Addendum No. 4 **Issued: November 17, 2026**

Project Name:	Pottsgrove High School Facilities & Athletic Improvements ICS Project No. S25009
Project Owner:	Pottsgrove School District 1301 Kauffman Road Pottstown, PA 19464
Construction Manager:	ICS – Scott Kennedy 1400 N. Providence Road Building 2, Suite 4025 Media, PA 19063

2 A3.0 STADIUM NORTH ELEVATION
SCALE: 1/8" = 1'-0"

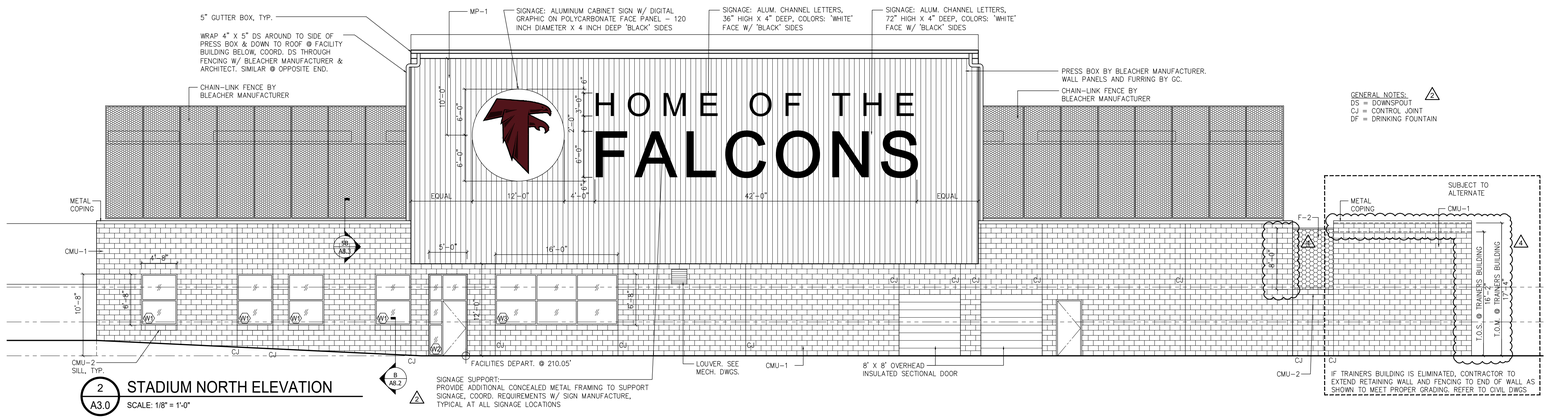
- Detail 2/A3.0, STADIUM NORTH ELEVATION, **MODIFY** the following:
  a. **ADD** dimension 8’-0” to chain link fencing, ‘F-2’, over retaining wall between facilities building and trainers building.
  b. Show top of masonry and **ADD** the following dimension:
     1) T.O.M @ TRAINERS BUILDING 17’-4”
  c. Show top of steel and **ADD** the following dimension:
     1) T.O.S. @ TRAINERS BUILDING 16’-2”

7B A8.1 SECTION
SCALE: 3/4" = 1'-0"

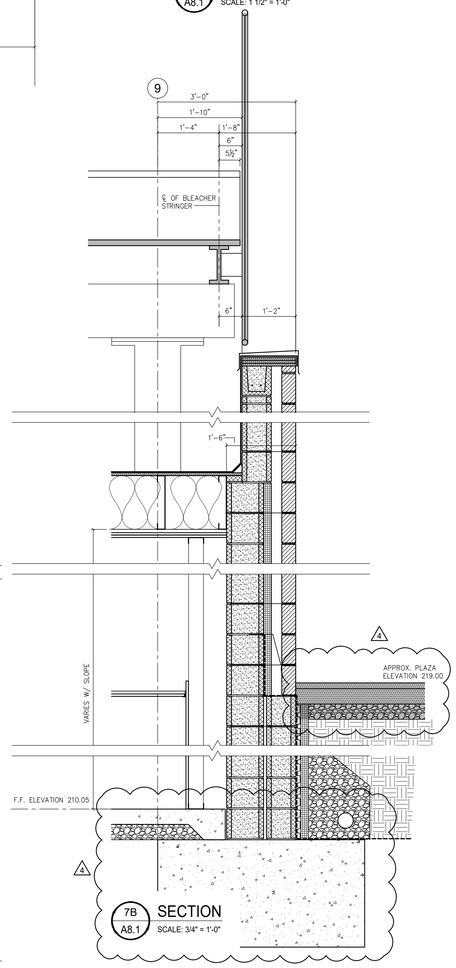
- Detail 1A/A8.1, Detail foundation modified
- Detail 7A/A8.1
  a. Detail foundation modified
  b. **ADD** solid ‘Gray’ hatch to chain link fencing, custom bracket, & 1/4" galv. steel plate.
- Detail 7B/A8.1
  a. Detail foundation modified
  b. **ADD** gray hatch to asphalt

1 SITE UTILITY PLAN - NORTH

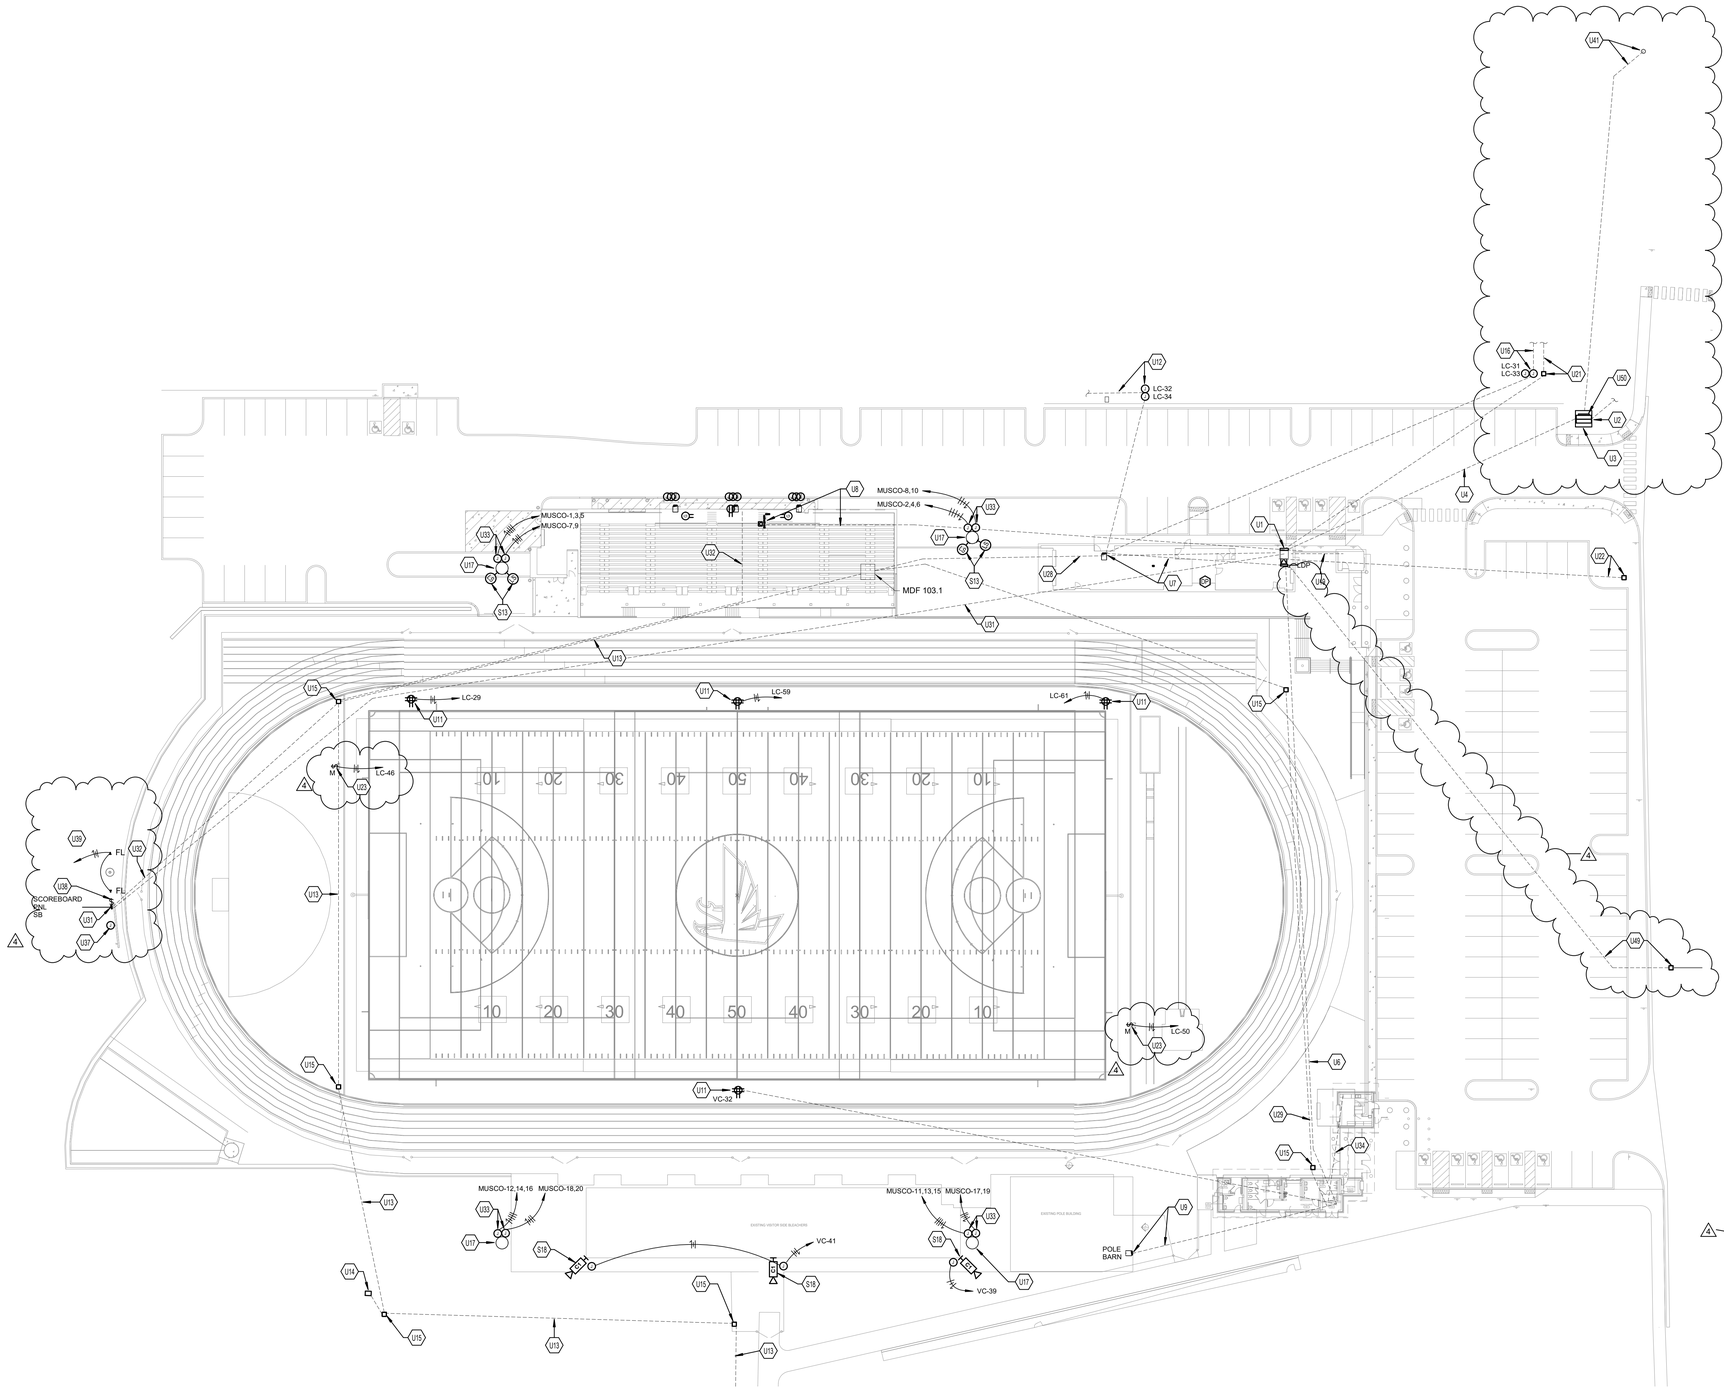
5.26 Drawing Sheet E-101 “ELECTRICAL SITE UTILITY PLAN – NORTH” (Reference attached Reissued Drawing):

- Added flagpole lighting/controls and power near scoreboard.
- Adjusted power requirements for scoreboard. New panelboard at scoreboard shall be included in the contract.
- Added backfeed for existing site lighting to plans.
- Added power for play clocks to site plan.

LIGHTING PLAN - HOME SIDE CONCESSIONS AND RESTROOM BUILDING

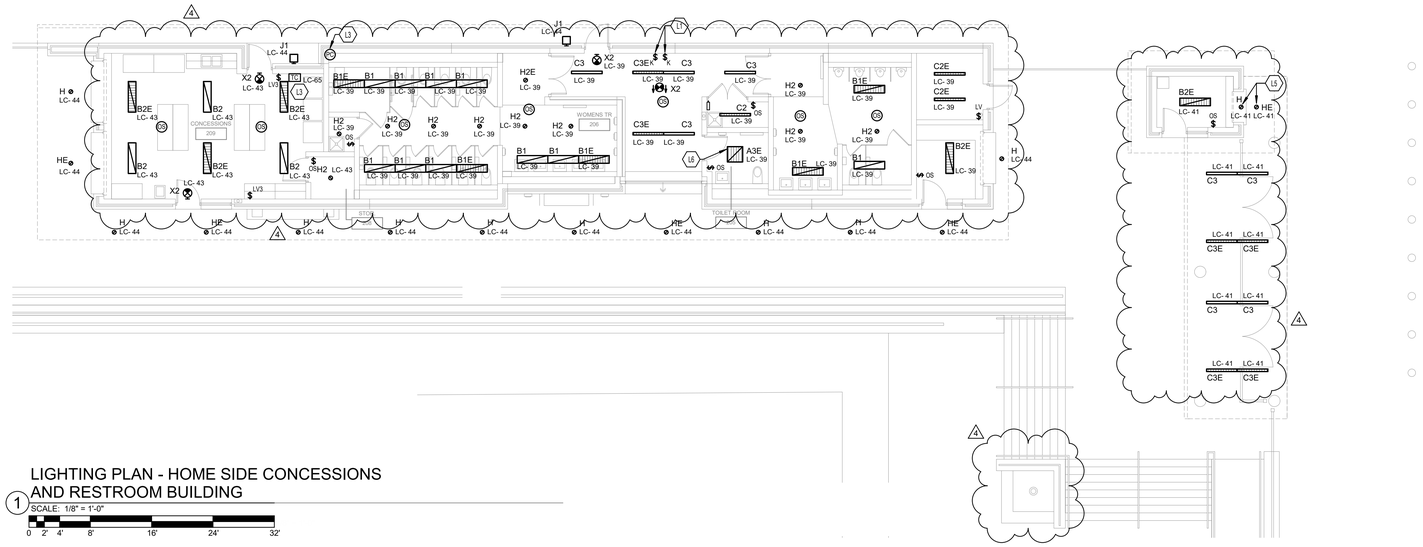
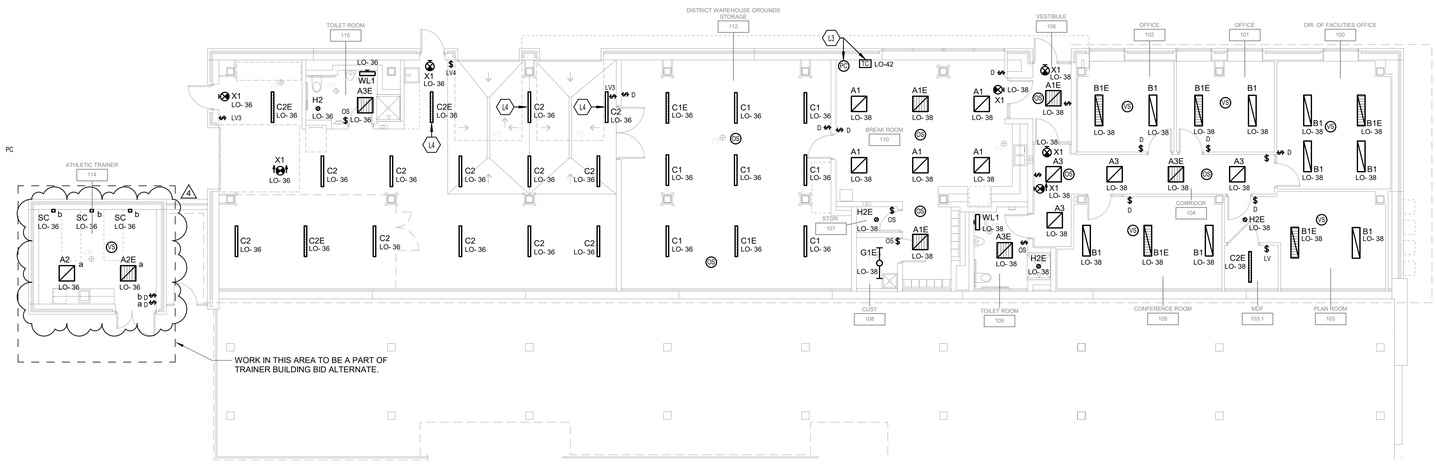
5.27 Drawing Sheet E-101 “LIGHTING PLAN – HOME SIDE PAVILLION” (Reference attached Reissued Drawing):

- Deleted flagpole lighting from this plan. These will be moved to be shown on Sheet EU-101.
- Shifted light switch in Concessions 209.
- Changed fixture types and switching scheme in Athletic Trainer Room.
- Changed and created new light fixture types to coordinate with ceiling types.
- Removed all scope associated with lighting in the Press box area.

POWER PLAN - HOME SIDE CONCESSIONS AND RESTROOM BUILDING

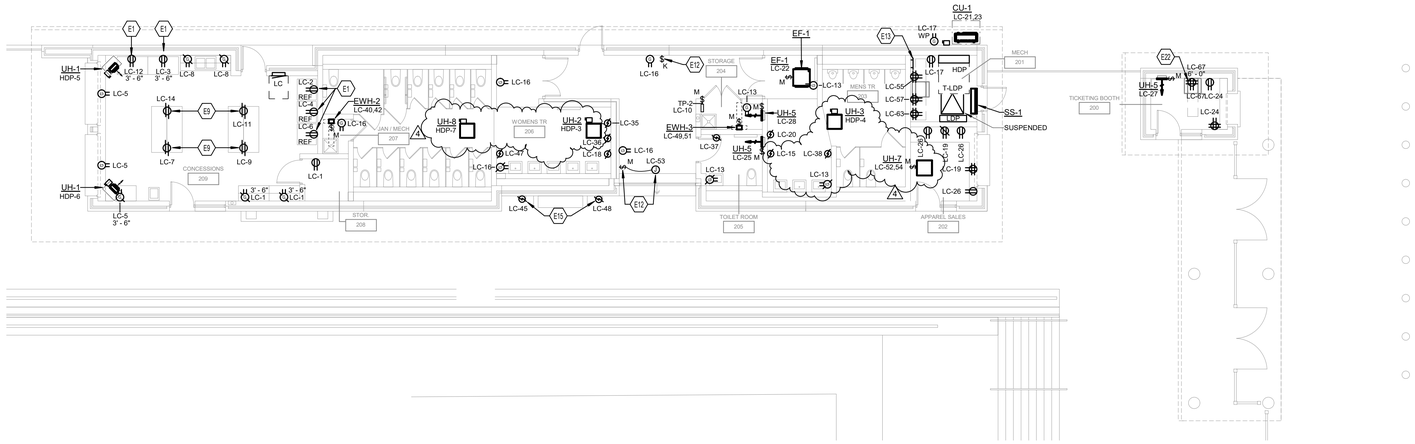
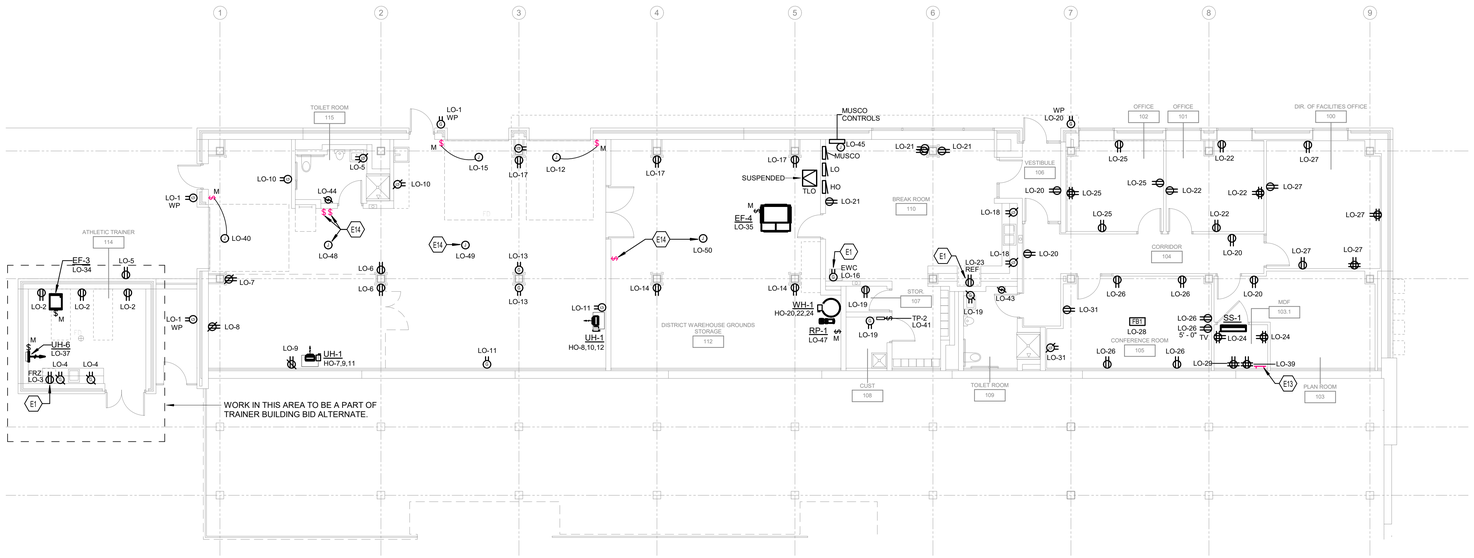
5.29 Drawing Sheet E-201 “POWER PLAN – HOME SIDE PAVILLION” (Reference attached Reissued Drawing):

- Updated heater changes.
- Updated Pressbox panels and notes. Deleted receptacles shown as these are to be installed by press box installer, with the exception of the panel near Panel PBB.
- Added dedicated circuits for pressbox exterior outlets and for sound rack.

FIRE ALARM PLAN - HOME SIDE
CONCESSIONS AND RESTROOM BUILDING

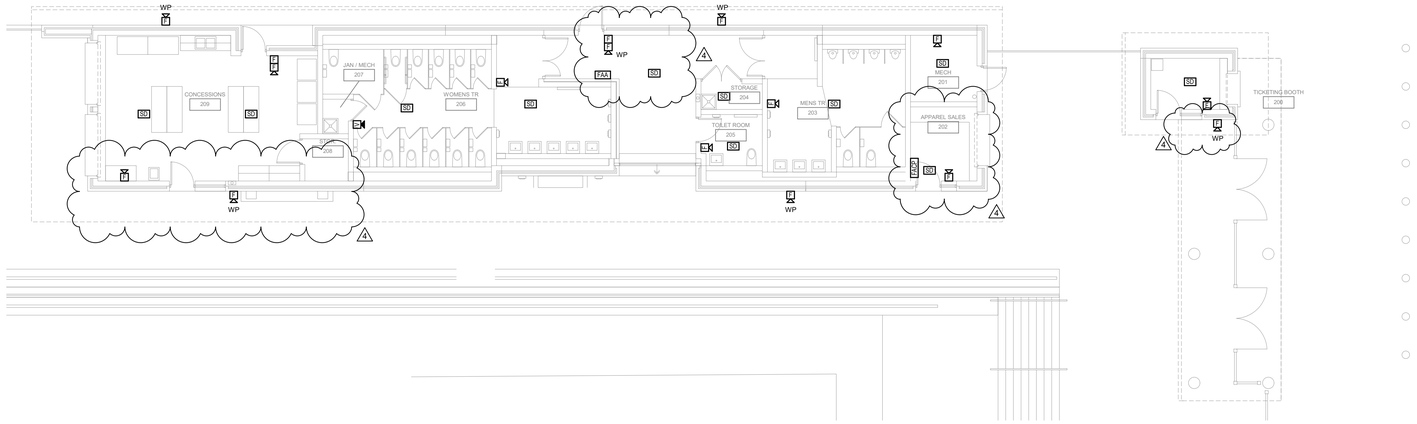
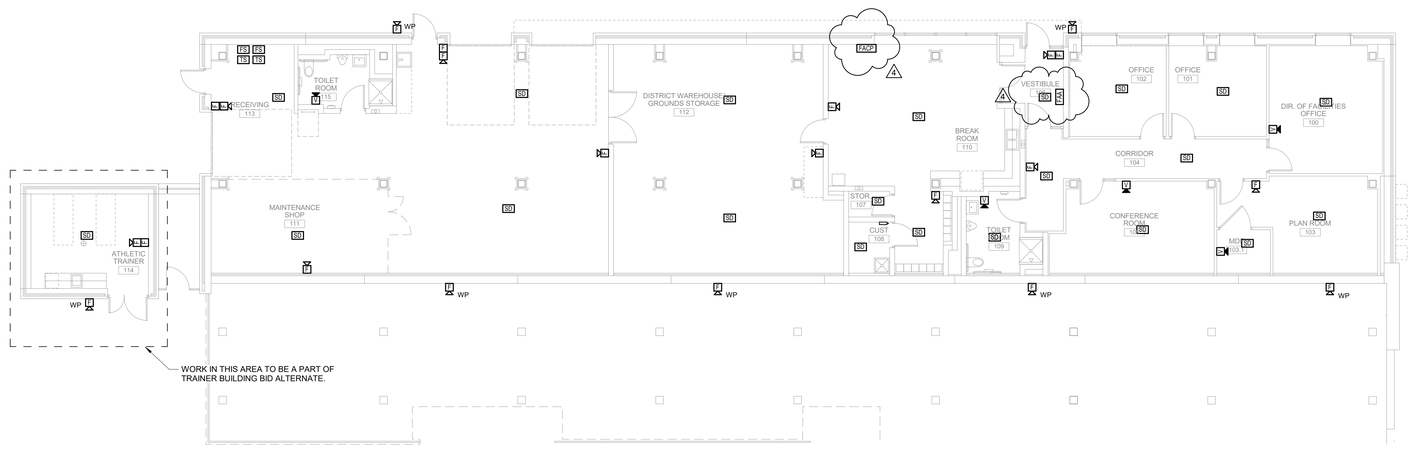
5.30 Drawing Sheet E-301 “FIRE ALARM PLAN – HOME SIDE PAVILLION” (Reference attached Reissued Drawing):

- Moved fire alarm device in Apparel Room 202.
- Shifted FA Device on exterior of Ticket Booth 200.
- Shifted FA device outside Concession 209.
- Moved FACP to Apparel 202.
- Added fire alarm annunciator to Home side buildings and relocated fire alarm control panel.

FIRE ALARM PLAN - VISITORS SIDE
CONCESSIONS AND BLEACHERS

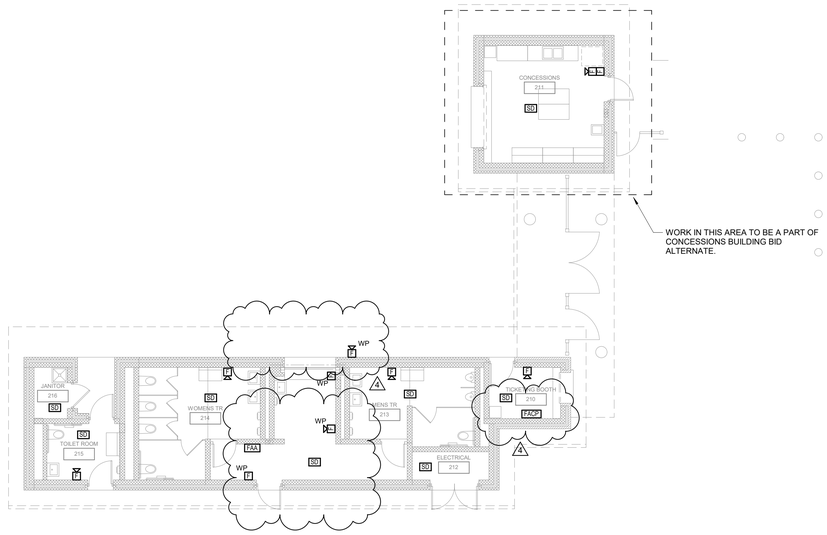
5.31 Drawing Sheet E-302 “FIRE ALARM PLAN - VISITIORS SIDE PAVILLION” (Reference attached Reissued Drawing):

- Shifted Fire Alarm device locations in restroom building.
- Moved FACP to Ticketing Booth 210.
- Added fire alarm annunciator to Visitor side buildings and relocated fire alarm control panel.
